MORKRUM MULTIPLEX PRINTING TELEGRAPH SYSTEM

METHOD FOR MAKING CHANGES

This supplement forms a part of Morkrum Specifications #111 and #112 dated January 1923 and February 1926, and covers the following new features:

FIGURE 1.

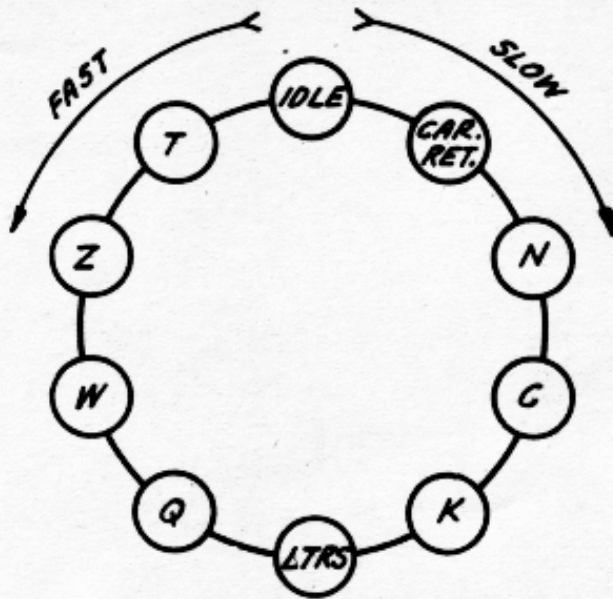
With the new idle signal the 1st, 2nd, 3rd and 4th pulses from each transmitter are of one polarity and the fifth of the opposite polarity. See figure 1.

The new idle signal makes it possible to get into phase if phase is lost while the distant station is not sending without asking the distant station to run correction. If the set runs out behind, the CAR. RET. signal will be received, and if it runs out ahead, letter "T" will be received. Figure 1 shows the sequence of letters obtained from the new idle signal.

FIGURE 3.

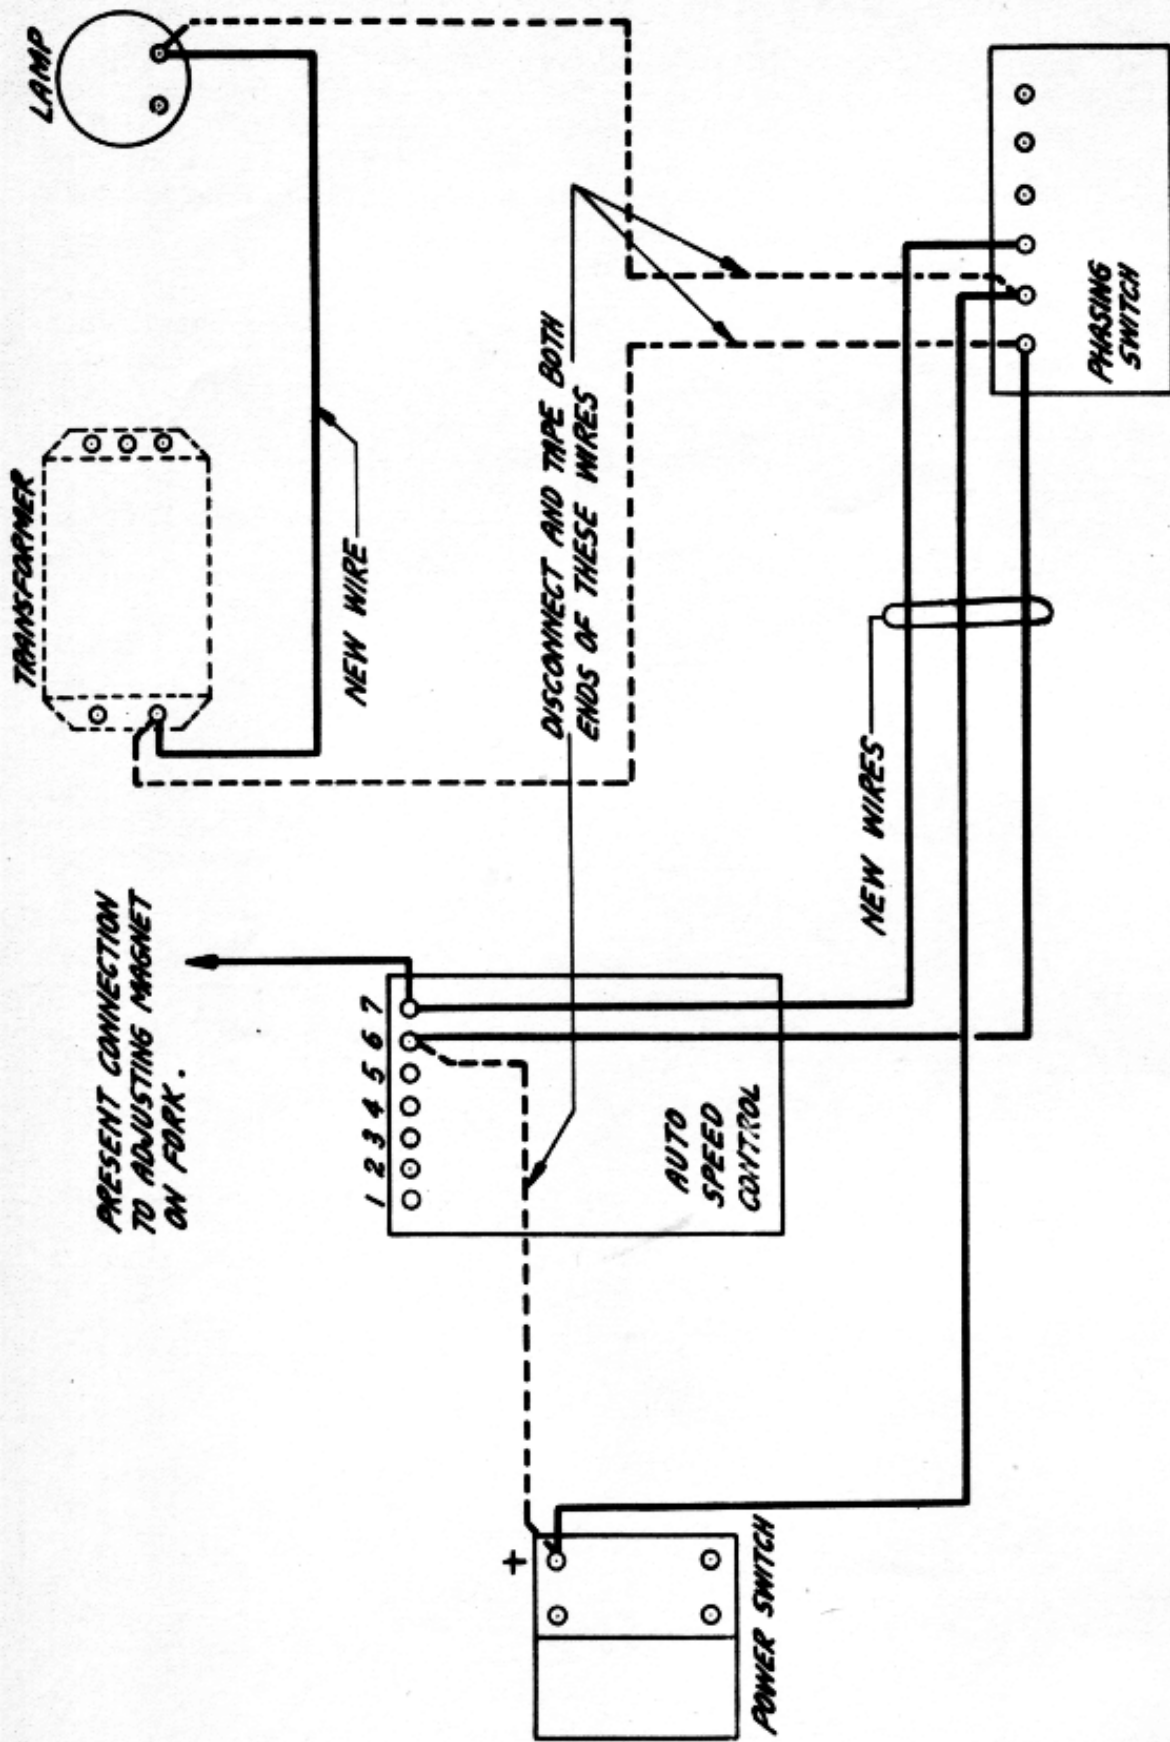
of this new feature, the new circuits are shown in figure 3.

When the tape is slack and the auto stop contacts are closed, a current pulse will be sent through the two windings of the relay coil and through the transmitter magnets whenever the transmitting operating contacts on the distributor are closed. The relay coil is differentially wound and current flowing through both windings will neutralize,- thus preventing the relay from operating.

When the auto stop lever is pulled up, the circuit to one of the relay coil windings is opened and the following closing of the transmitter operating contacts will cause current to flow through one winding of the coil,- thus operating the relay which locks itself in through its left hand tongue and front contact. The transmitter is locked in through the right hand tongue and front contact.

When the auto stop contacts are again closed, a pulse from the transmitter operating contacts will send current through both windings of the relay coil de-energizing the relay and causing it to release the transmitter and unlock itself.

The phasing switch has been re-wired as shown in figure 3. The switch has been removed from the AC side of the rotary and is arranged to short-circuit or open the auto speed control rheostat circuit. When the switch handle is towards the left (normal) the rheostat is in the circuit; with switch handle in center position the rheostat circuit is open; with switch handle to right, the rheostat is short-circuited.

Disconnect and tape two wires going to left hand and center terminals on phasing switch and also ends connected to transformer and lamp.

Disconnect and tape wire on #6 auto speed control unit table clip and other end of wire connected to + terminal on power switch.

Run new wires between transformer and lamp; phasing switch and auto speed control; and phasing switch and power switch as shown in figure 3.

FIGURE 4.

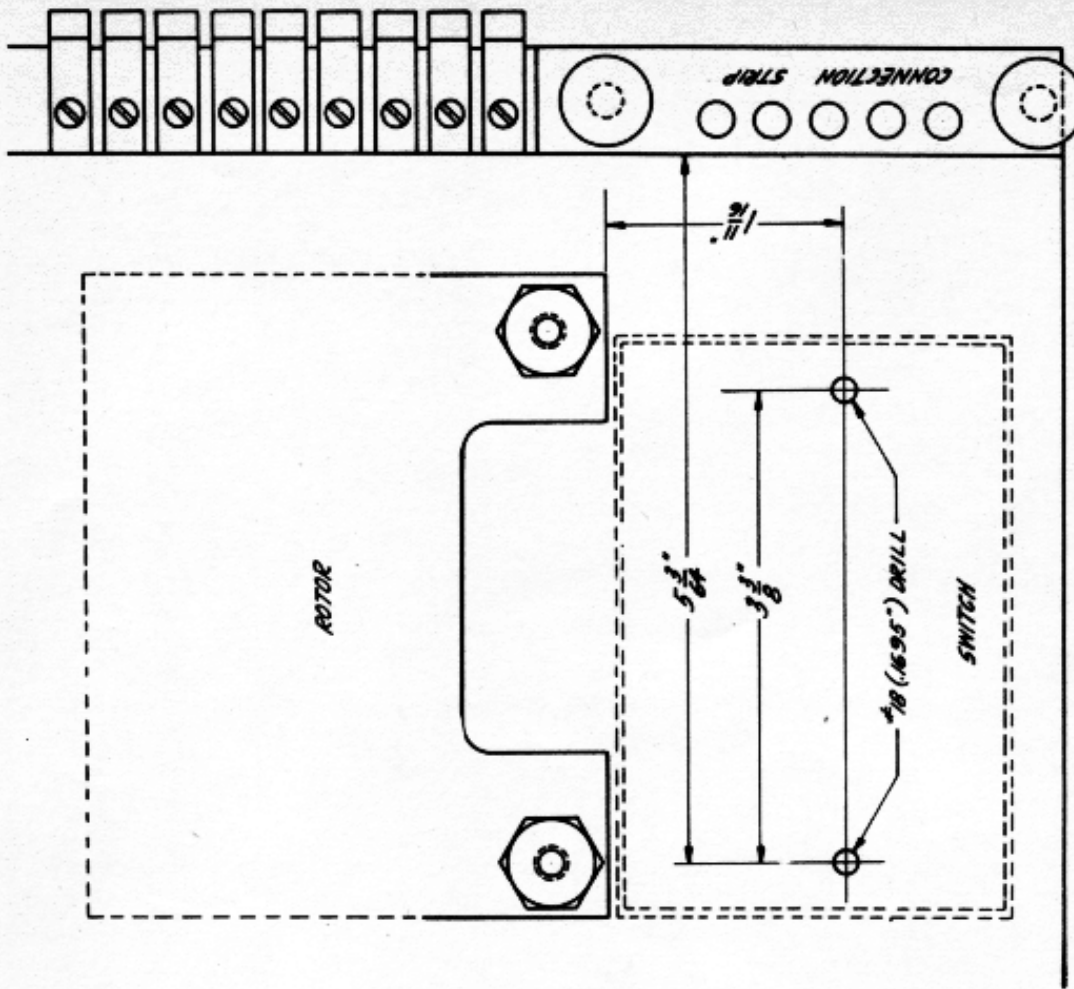
TRANSMITTING DISTRIBUTOR - FIGURE 4 AND WIRING DIAGRAM 843

The following new parts are required for each transmitting distributor:

- 1- #6417 six point switch (AC switch)
- 2- #33-274 screw
- 2- #2263 nut

Mount the AC switch on distributor in the position shown in figure 4. Drill two holes with a #18 drill and fasten the switch to base with the screws and nuts. The holes must be accurately located to provide proper clearance for mounting nuts and also to permit positioning of rotor for gear and pinion clearance.

Re-wire distributor which is wired according to diagram #559 in Supplement #4 to conform to connections shown in diagram #843.

FIGURE 5.

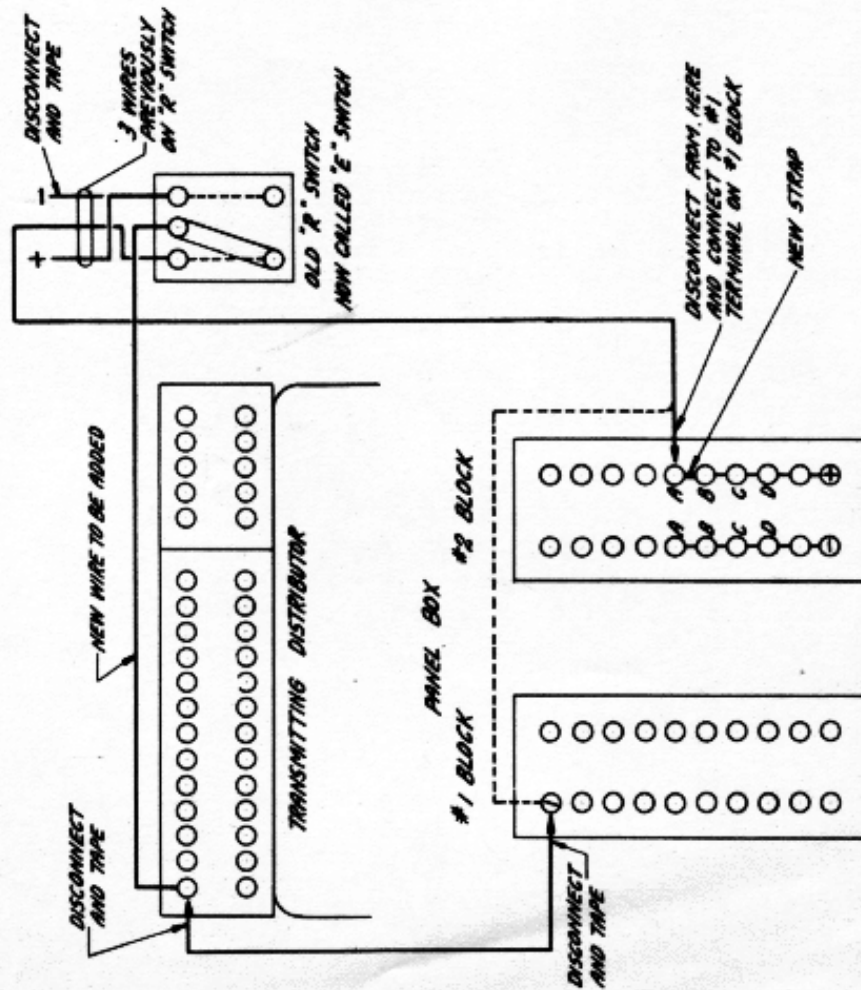
DISTRIBUTOR TABLE CHANGES FOR NEW "E" SWITCH - FIGURE 5.

Remove and tape the wire on #1 transmitting distributor table clip and #1 terminal on #1 block in panel box.

Remove and tape wire on right hand terminal of "R" switch. Move wire from left hand terminal to right hand terminal, and wire from center terminal to left hand terminal. Disconnect wire from +A terminal on #2 terminal block in panel box and connect this wire to #1 terminal on #1 terminal block.

Run wire from #1 transmitting distributor table clip to center terminal on "R" switch.

Add strap between +A and +B terminals on #2 terminal block in panel box.

OPERATING TABLE WIRING CHANGES
FIGURE 6.

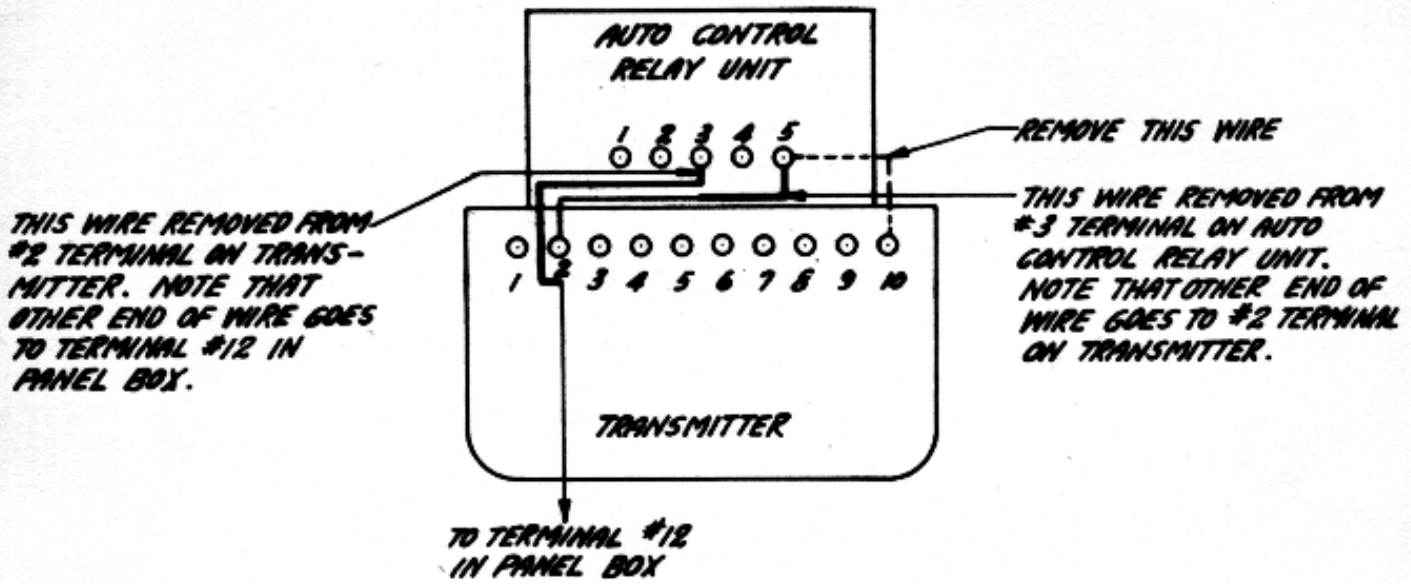
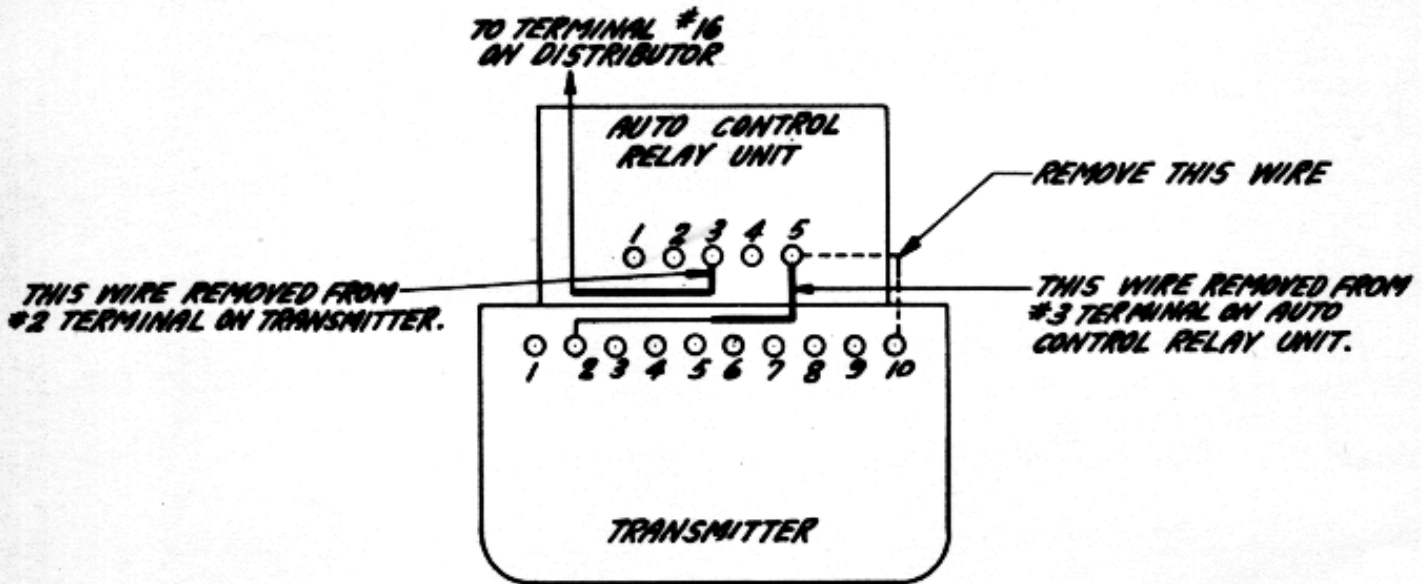
CHANGE IN OPERATING AND TEST TABLE WIRING FOR NEW AUTO STOP RELAY UNIT.

Figure 6 shows the wiring changes in operating table and figure 7, the changes in test table.

The changes are made as follows: Remove wire between #5 terminal on relay unit and #10 terminal on transmitter. Remove wire from #3 terminal on relay unit and connect it to #5 terminal on relay unit. Remove wire from #2 terminal on transmitter and connect it to #3 terminal on relay unit.

Be sure that the proper wires are disconnected from #2 terminal on transmitter and #3 terminal on relay unit. See figures 6 and 7.

WIRING
DIAGRAM
M2CRD 7
DISTRIBUTOR

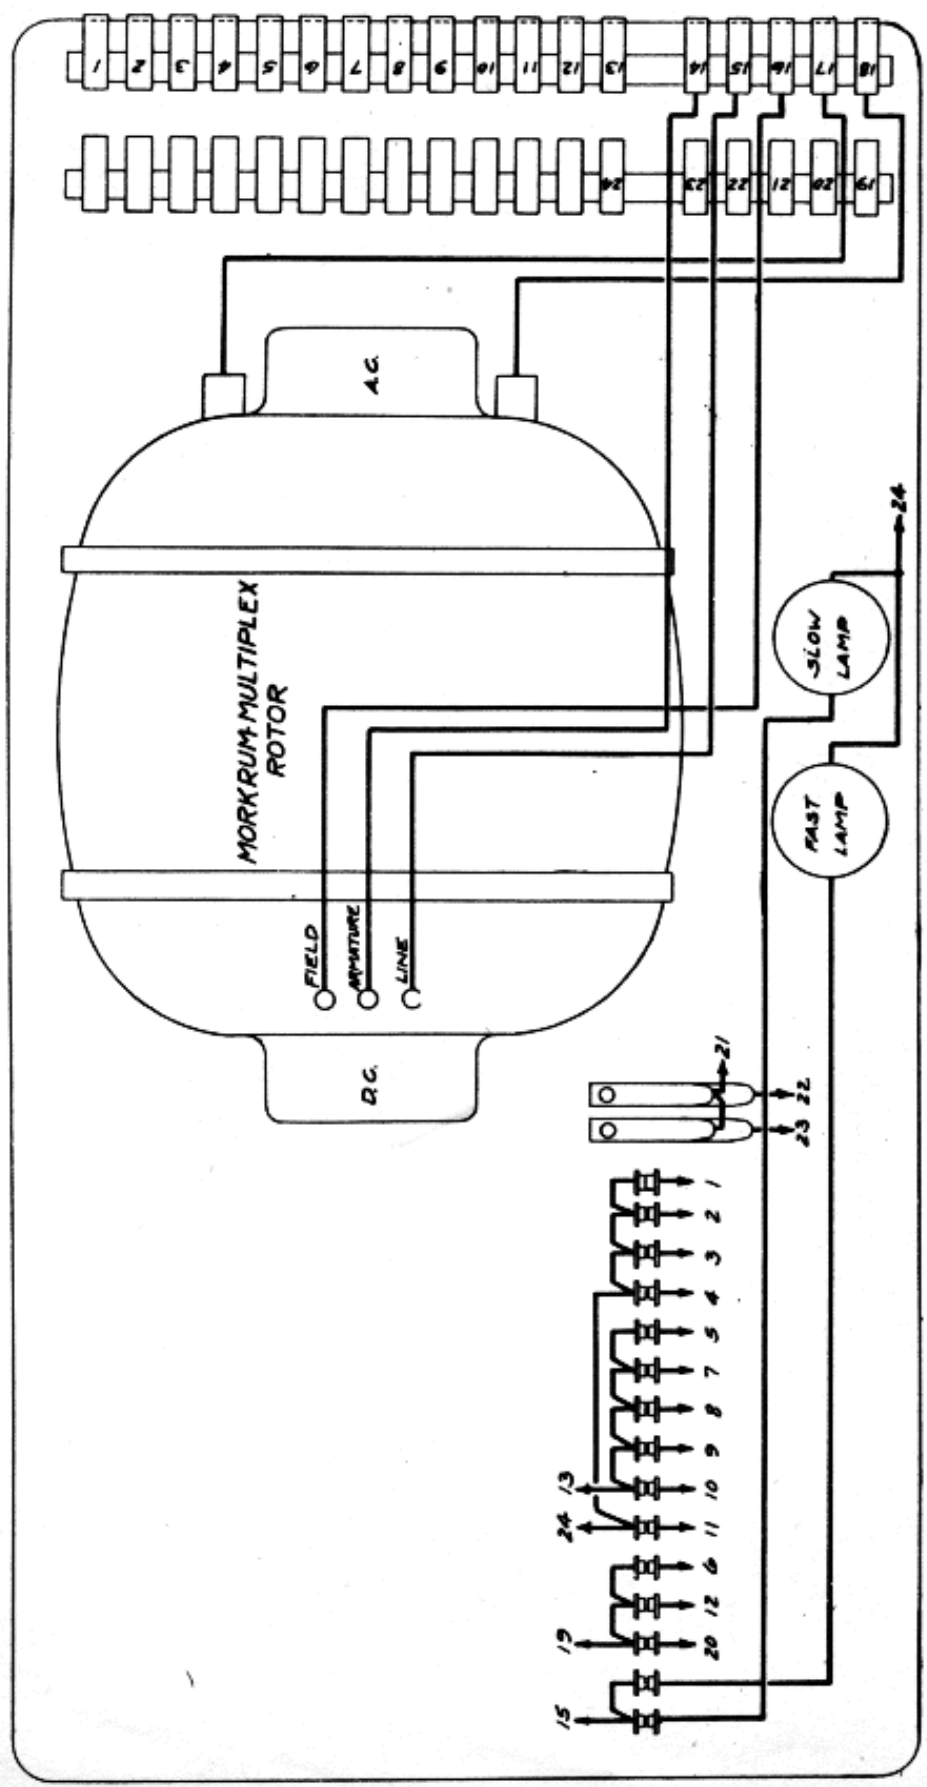
Change wiring of the ten receiving contacts from that shown on drawing #488 in bulletin 111 or 112 to conform to diagram 844. Note that the only changes are the straps on ten contacts and transposition of wires 13 and 24.

WIRING DIAGRAM
FOR DISTRIBUTOR
MTD 4

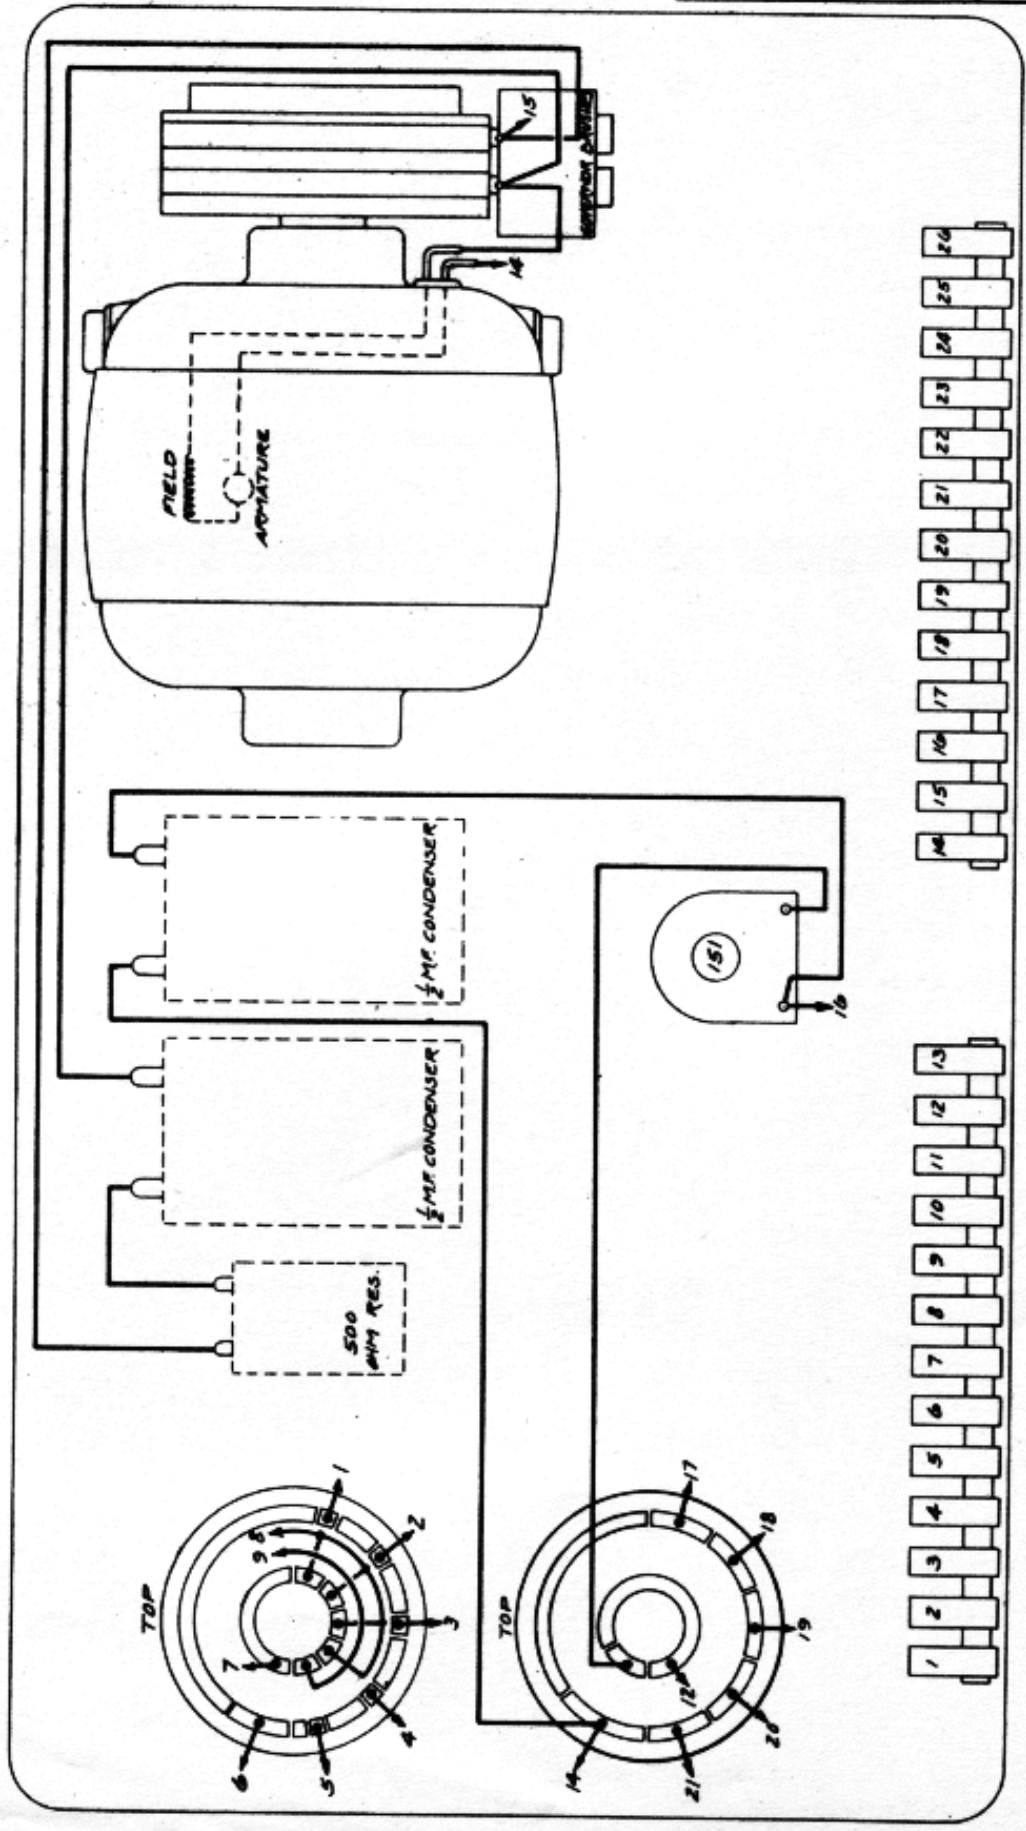
Remove wires and straps from commutator segments of inner ring and re-wire as shown in diagram.
